RE: Gateway Determination Review: 30-46 Auburn Road, Regents Park – Council Response (PP_2016_CBANK_001_00)

ATTACHMENT A: REASONS FOR NOT SUPPORTING AN INCREASED FSR

30-46 Auburn Road, Regents Park

Peer review of Pacific Planning's letter titled 'Gateway Determination Review (PP_2016_CBANK_001_00) – 30-46 Auburn Rd, Regents Park, dated 17 April, 2020

Figure 3: Scenario A Solar Analysis of Applicant's Design - 6, 8 and 12 storey buildings (Source: Architectus, 2020)

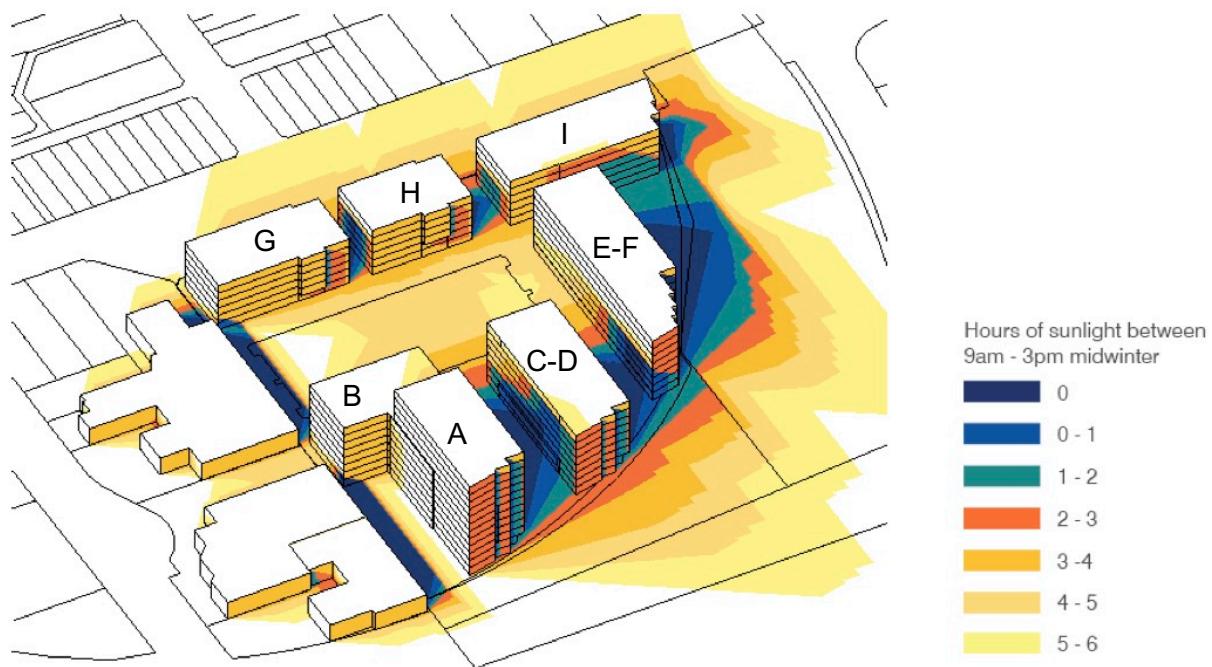
The solar analysis Scenario A identified that none of the buildings in the latest 'DA level' design is achieving the minimum 2 hour solar access to balcony and living areas between 9am-3pm on 21 June to 70% of apartments. As detailed in Attachment B, the latest design

does not achieve the 70% requirement on any building, with compliance ranging 32.7% to 66.7%. It is anticipated that the non-compliance is due to a high number of south facing apartments and impacts from other buildings (i.e. Building A on Building C-D) as shown in Figure 3. Council notes that in Scenario B as shown in Figure 4, the overshadowing impacts from other buildings is dramatically decreased by the adoption of an 8 storey height limit.

Above: Architectus markup of sections. Note: these indicative studies provide only high level consideration of appropriate ground level – appropriate levels to be investigated further by the Proponent.

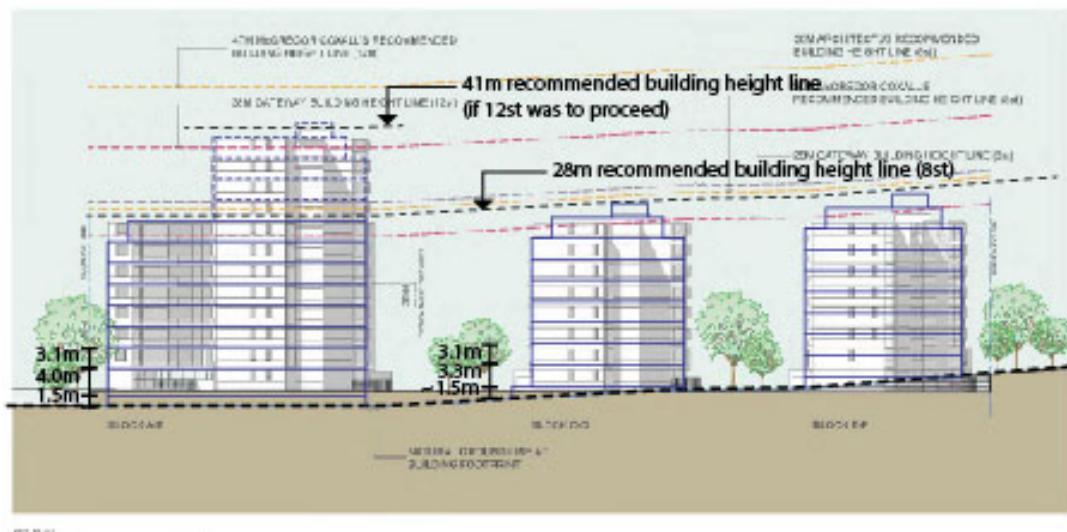
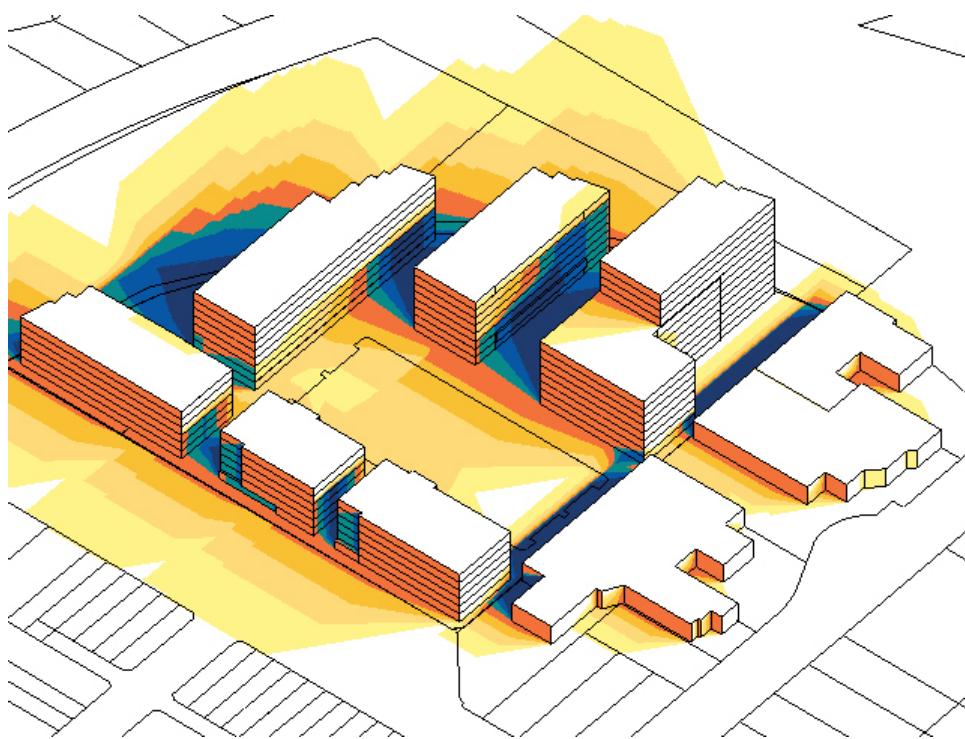
zone does not need to be provided for in the maximum height plane. (Refer to the Architectus markup of sections in the Appendix of this review).

Above: North-east axonometric solar heat map, at 1 minute intervals between 9am-3pm 21 June, Note: indicative model only by Architectus, modelled off envelopes provided off Pacific Planning, using 3.1m floor to floor heights for each level, and a flat terrain.

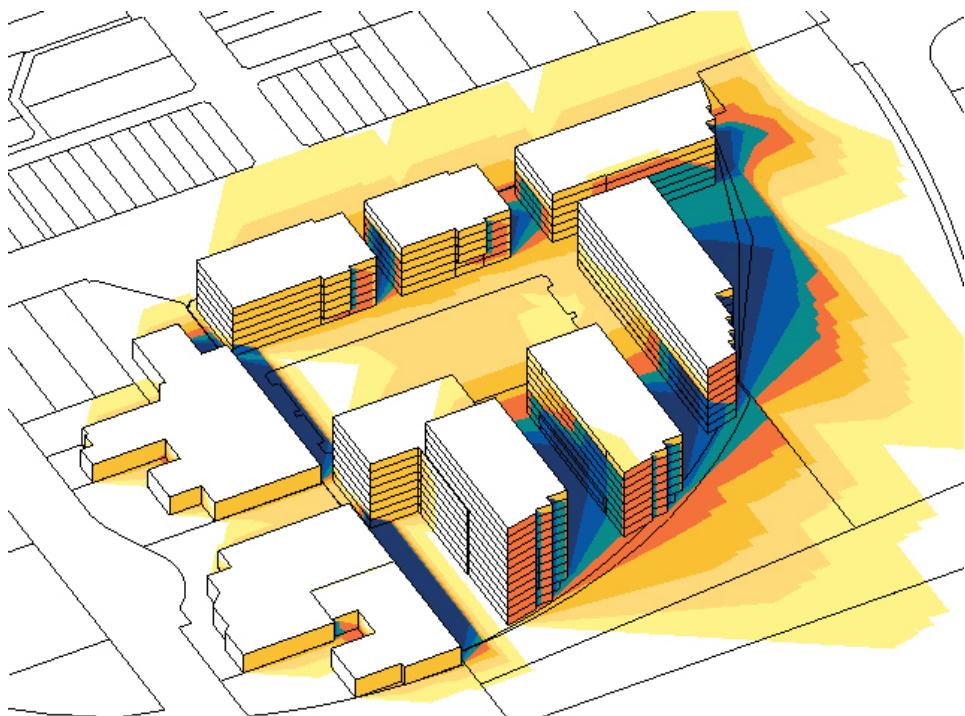
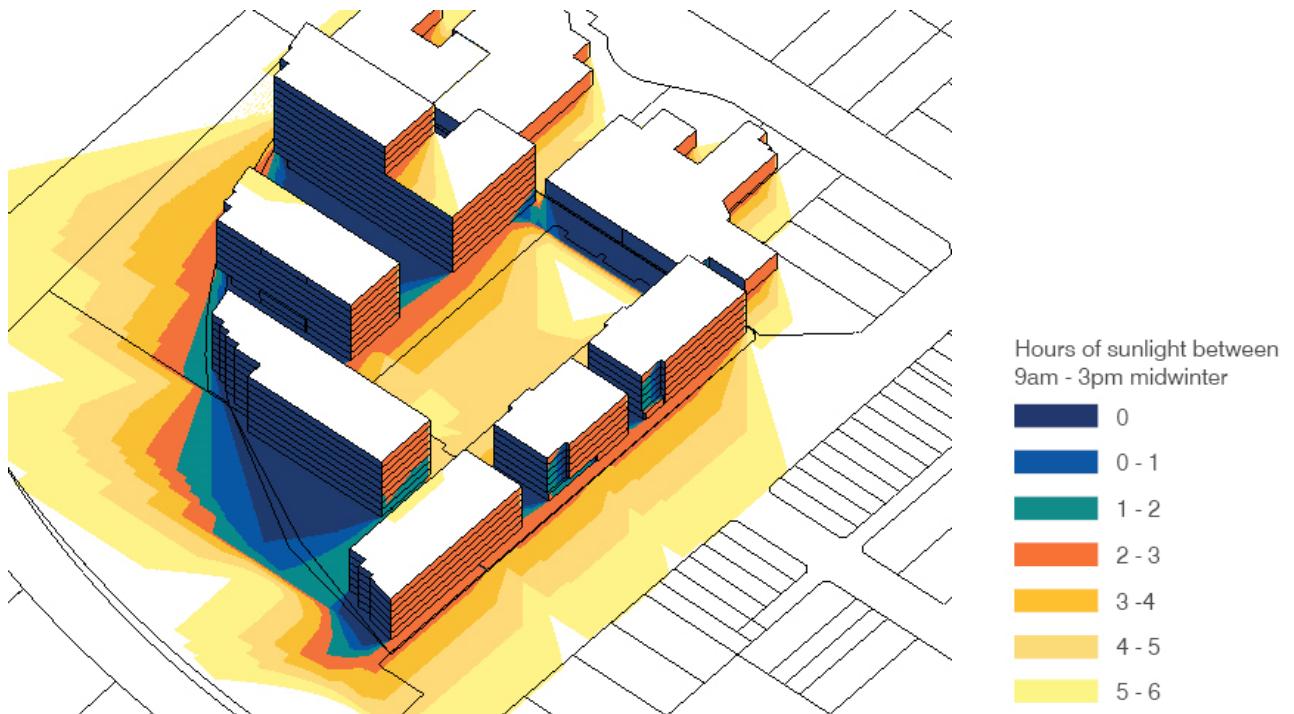
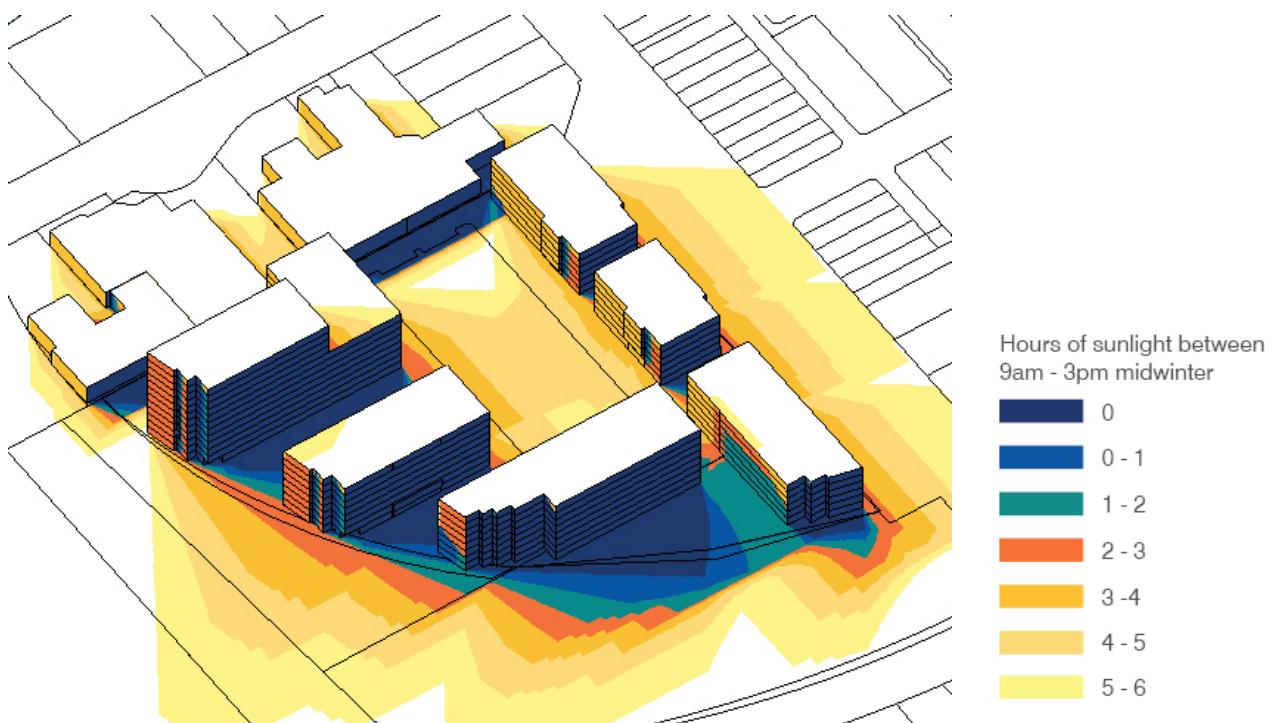
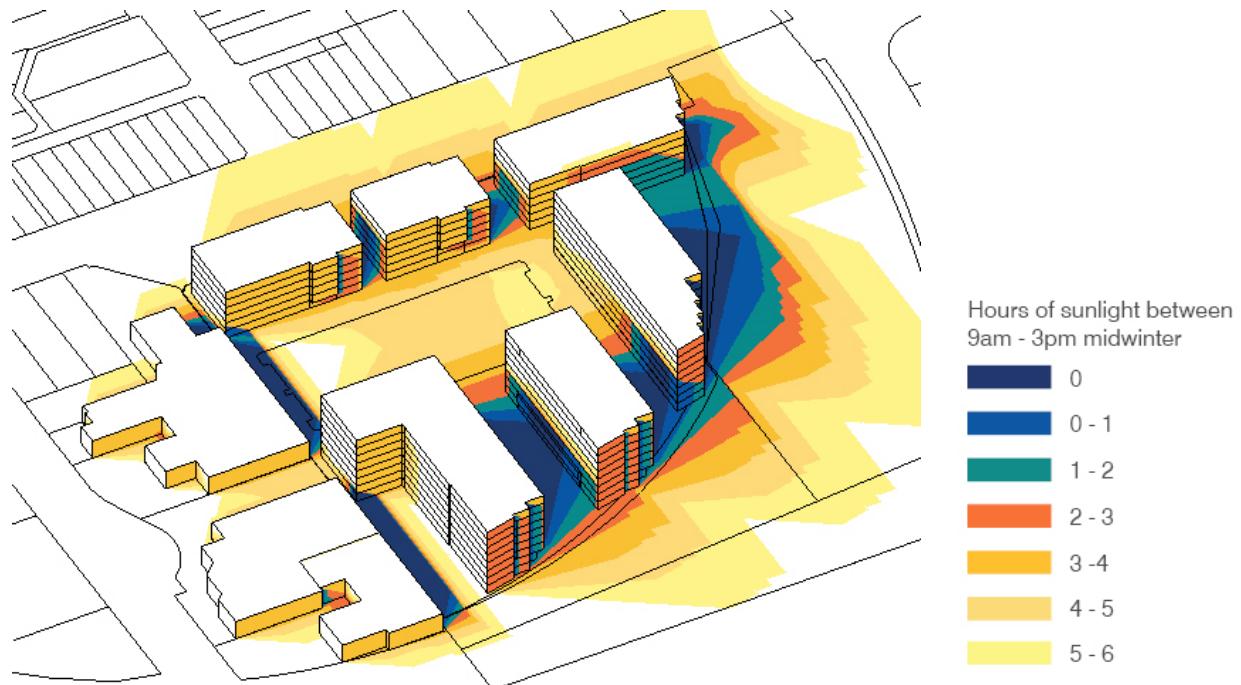
- Based on our assessment, the proposal does not appear to be achieving the minimum solar access design criteria to any of the apartment blocks. In view of these major discrepancies, Architectus recommends that all units must be verified in plan and sun's eye view to demonstrate 2 hour's mid winter solar access.
